Reference No: 15023 / L5

**RE: Stockyard Hill Wind Farm
Landscape & Visual Assessment**

I have reviewed the Department's 'Further Information Request, particularly Item 2, which requests:

Figure 2 Vegetation heights to achieve effective screening

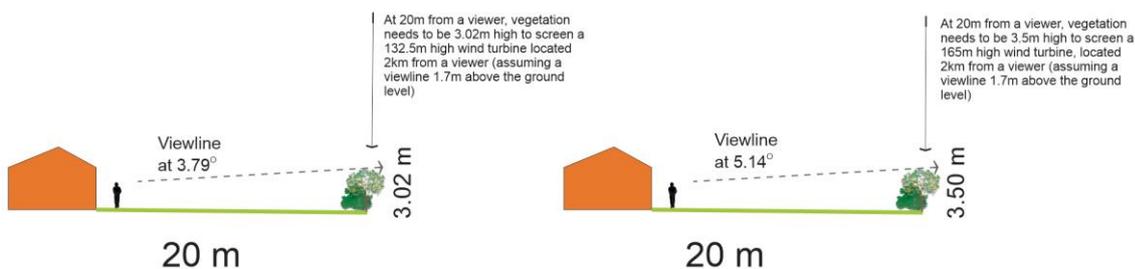
Figure 2 shows planting some 20 m from a viewing location or house. A distance of 20 m was considered adequate for fire setback and to ensure that the house perimeter was uncluttered.

The height of the planting needs to reach 3.02 m in height to screen a 132.5 m high wind turbine for a viewer with an eye level approximately 1.7 m above the ground line. This vegetative height needs to be 3.50 m to screen a 180 m high wind turbine. This increase of only 0.5 m in boundary planting height is a small height difference.

Planting would be more effective if planted closer to the house. If owners wished planting closer to the house, then this would be more effective and conversely if planting was located further away, then it would take longer to reach the greater height required to screen the view to wind turbines. The difference in height of the vegetation to achieve screening is not dissimilar, whether the vegetation is screening a 132.5 m high wind turbine or a 180 m high wind turbine.
